Light Horse Business Centre: Environmental Assessment Report

September 2011

Modification 3

Figure 2.1: Area D

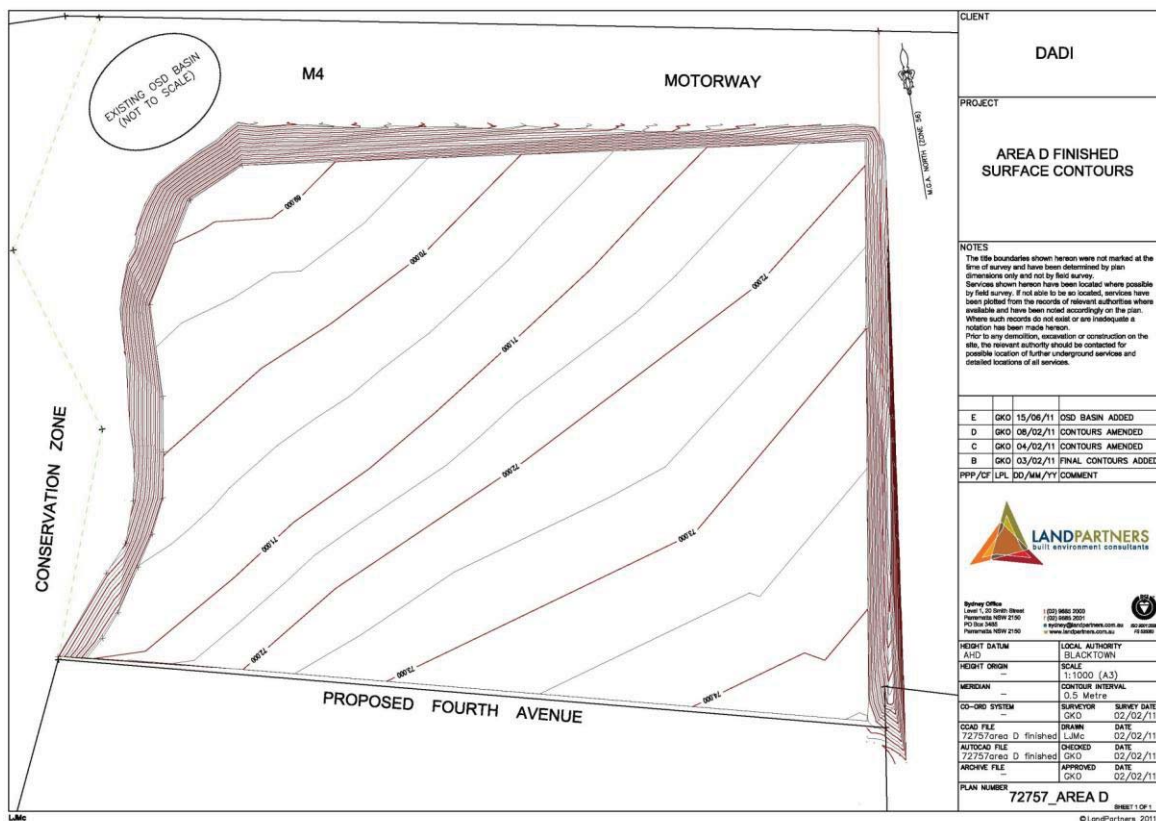
It is proposed that the final landform levels of the fill pad at Area D be changed from the levels shown in Hyder Consulting Pty Ltd plan DA001 dated 28 April 2009, to the levels shown in LandPartners Consultants plan 72757_AREA D dated 2 February 2011.

Area D shown marked in Figure 2.1 (below).

Figure 2.2: Area D filled levels

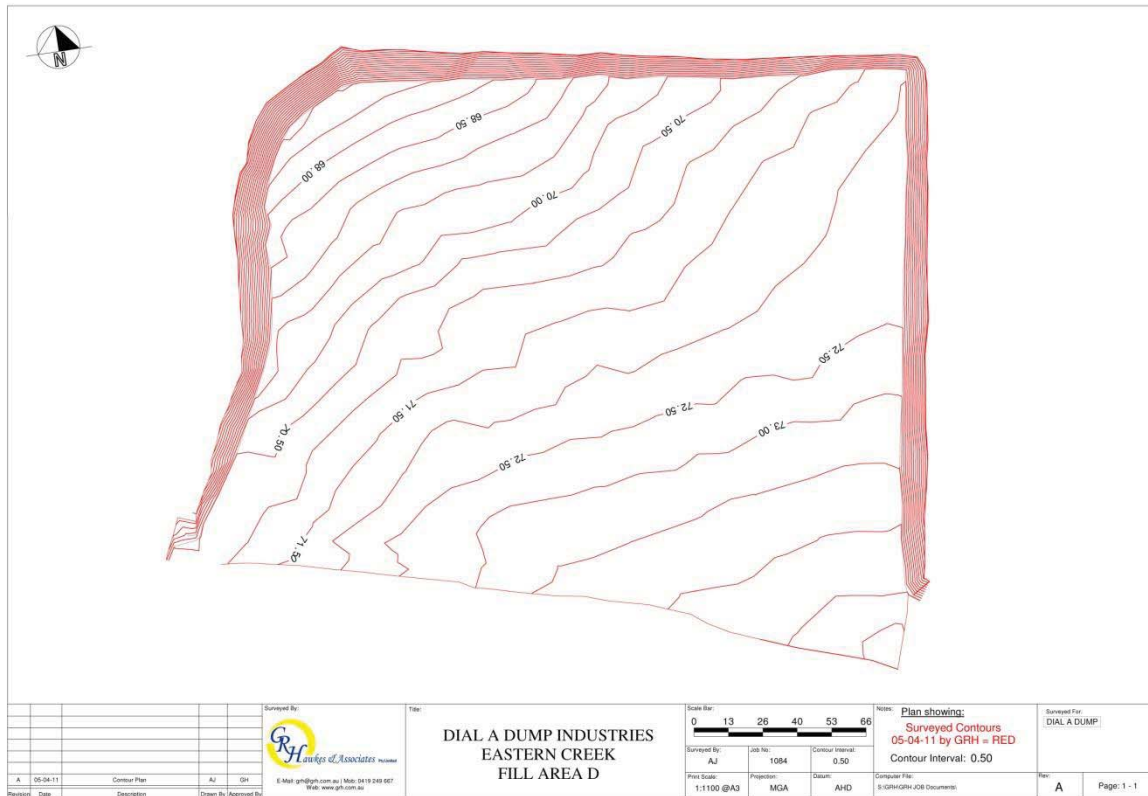
Area D has been filled to the levels shown in Figure 2.2 (below).

Figure 4.1: Site Plan

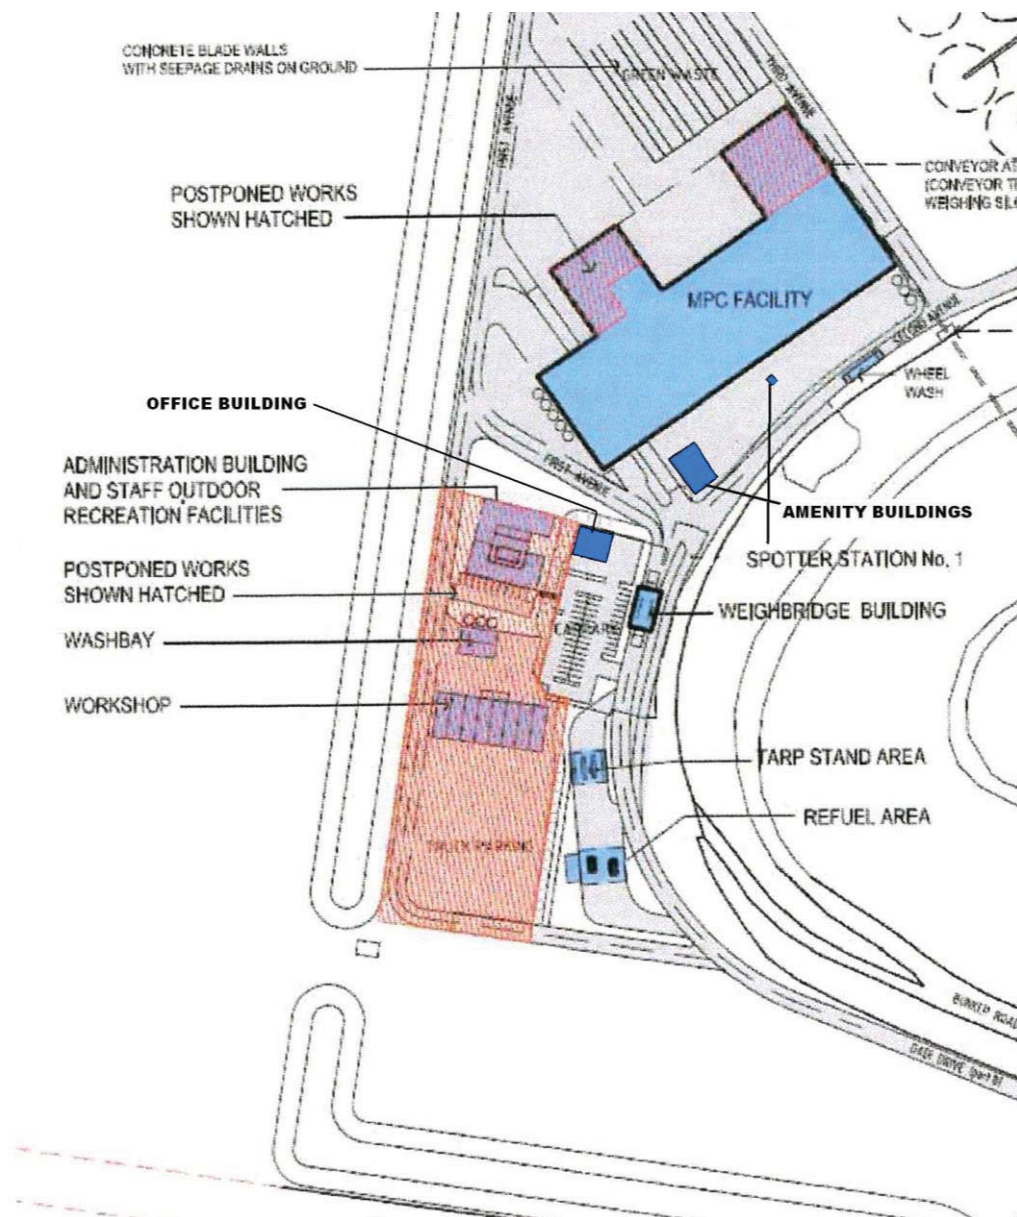
The weighbridge building is marked in Figure 4.1 (below).

Figure 5.1: Site Plan

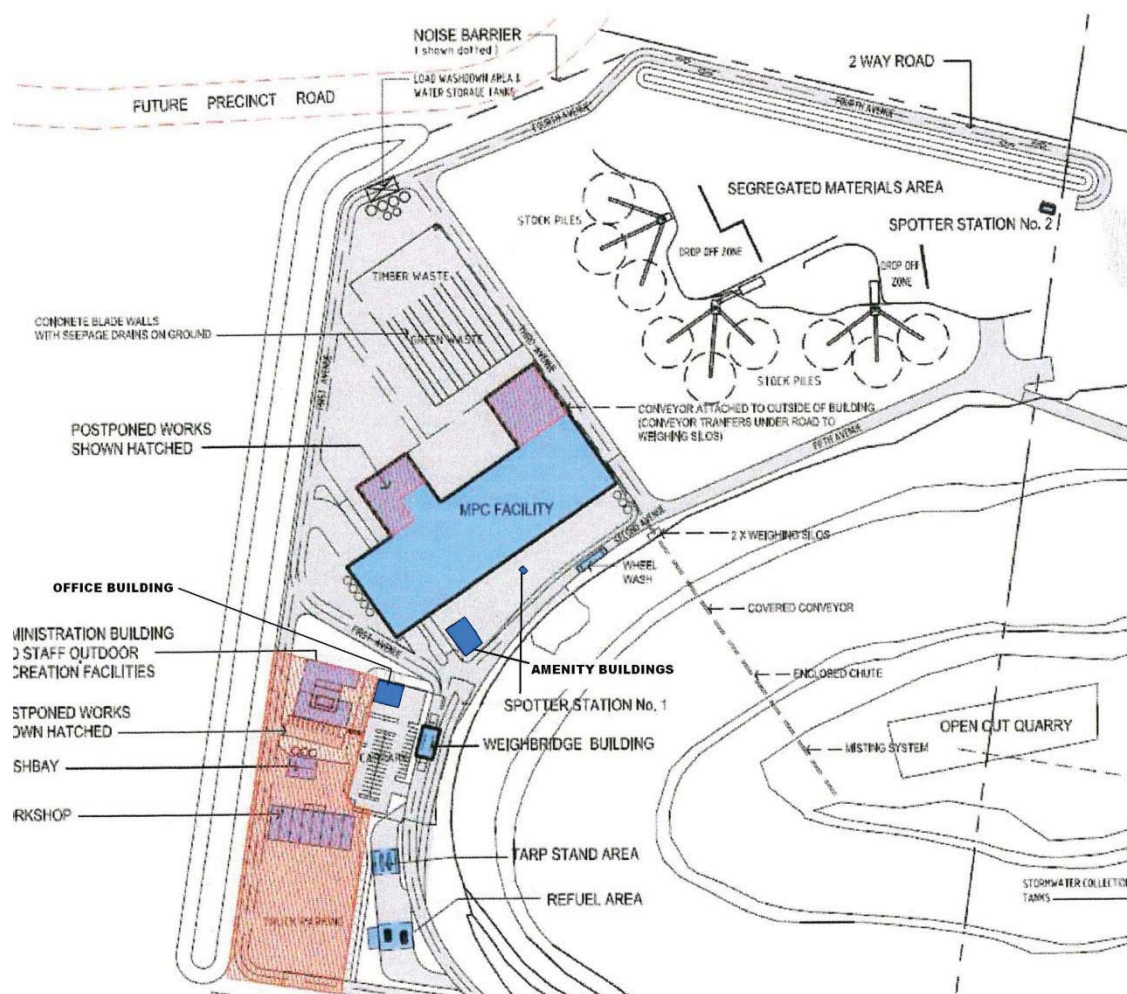
The buildings are shown in Figure 5.1 (below).

Figure 5.1: Site Plan

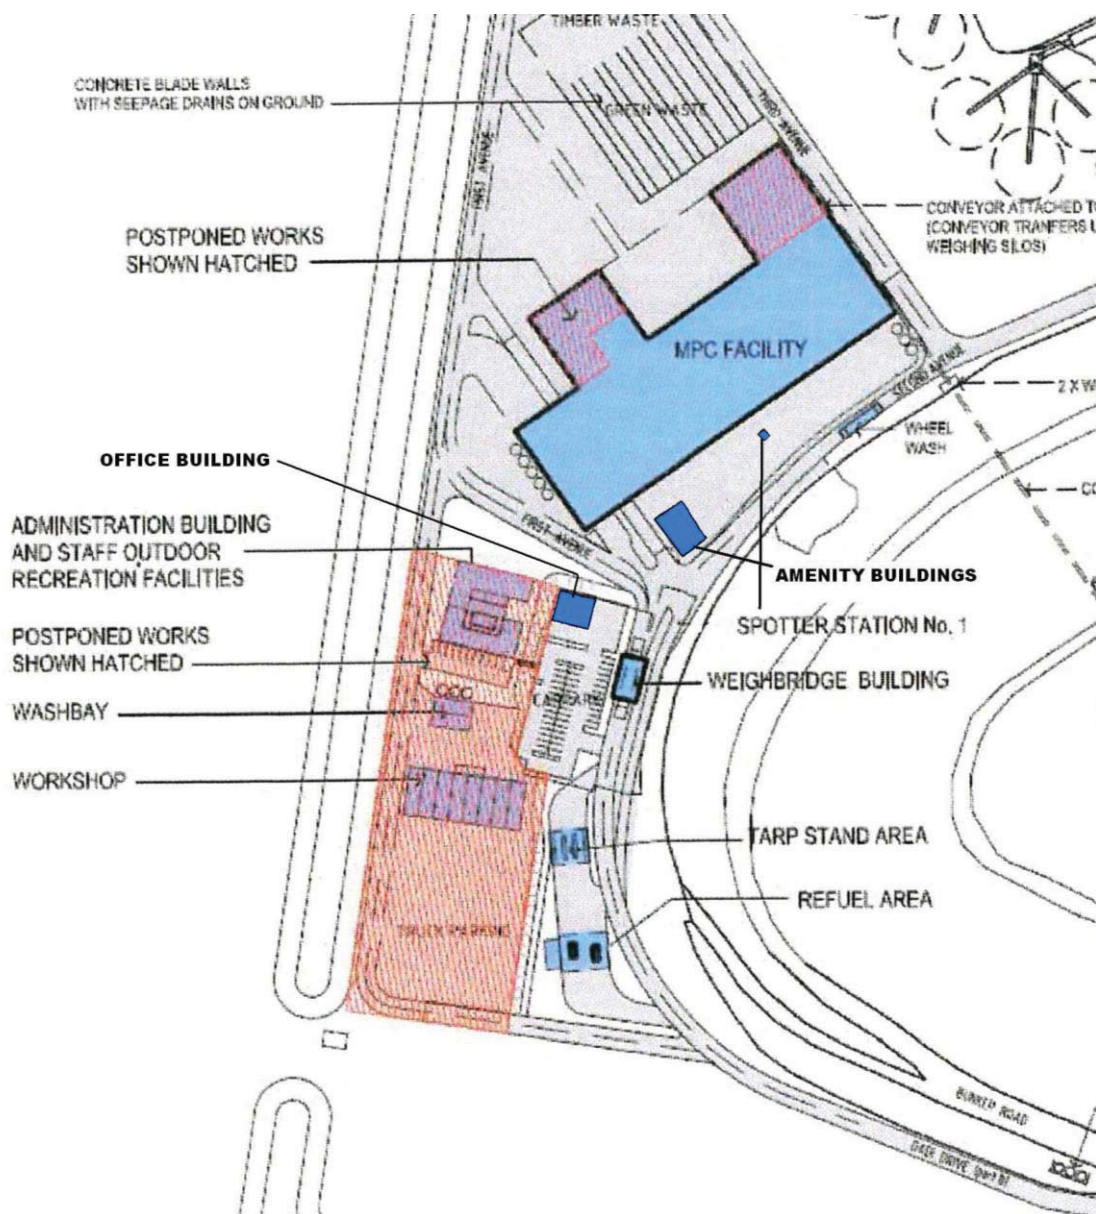
The buildings are shown in Figure 6.1 (below).

Figure 5.1: Site Plan

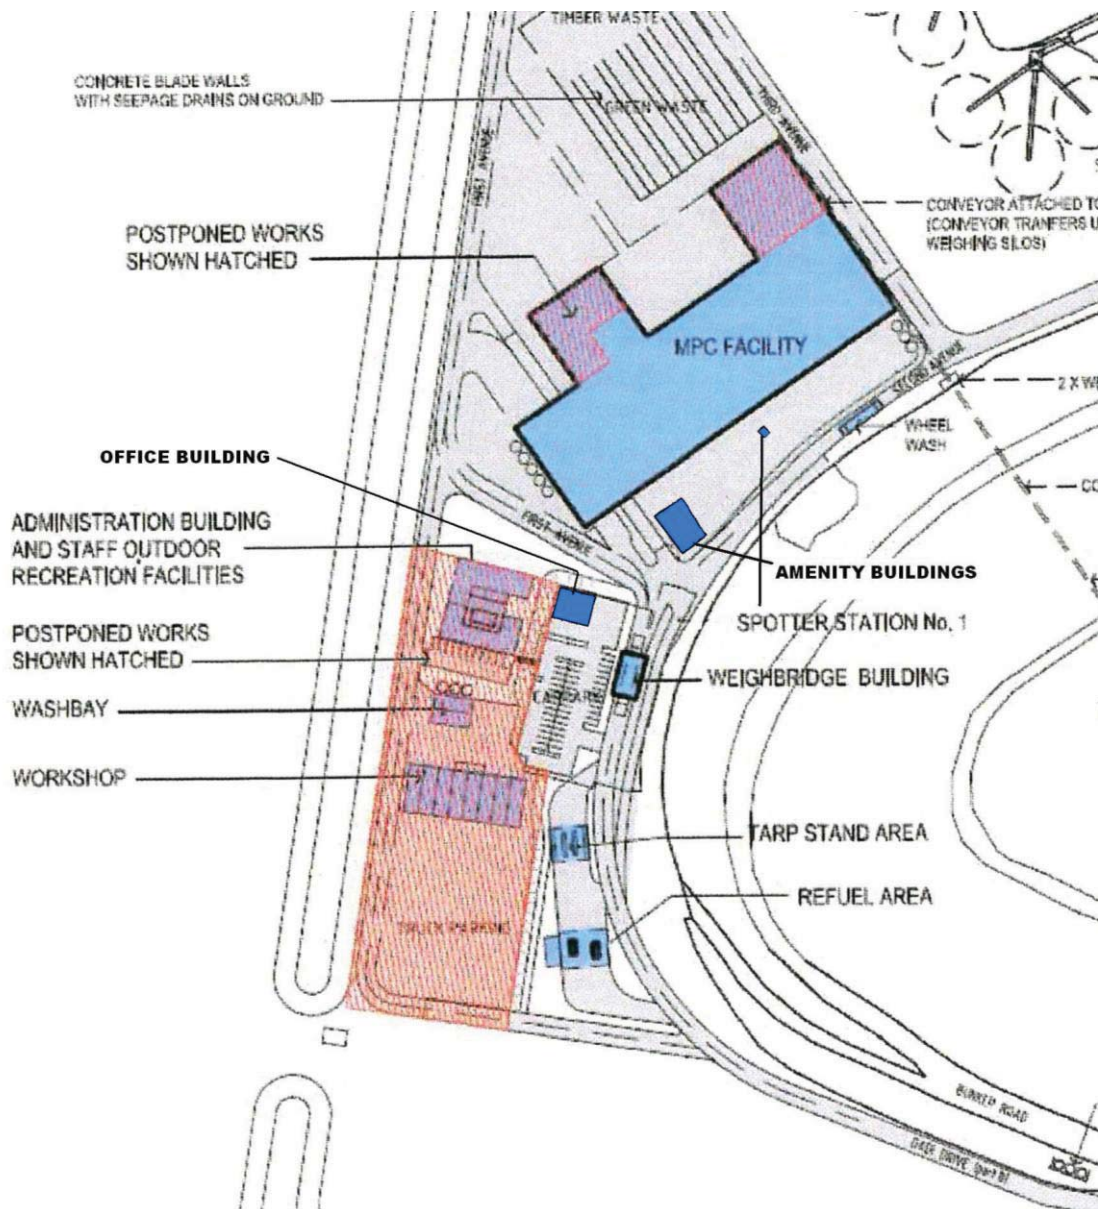
The Tarp Stand Area is shown in Figure 7.1 (below).
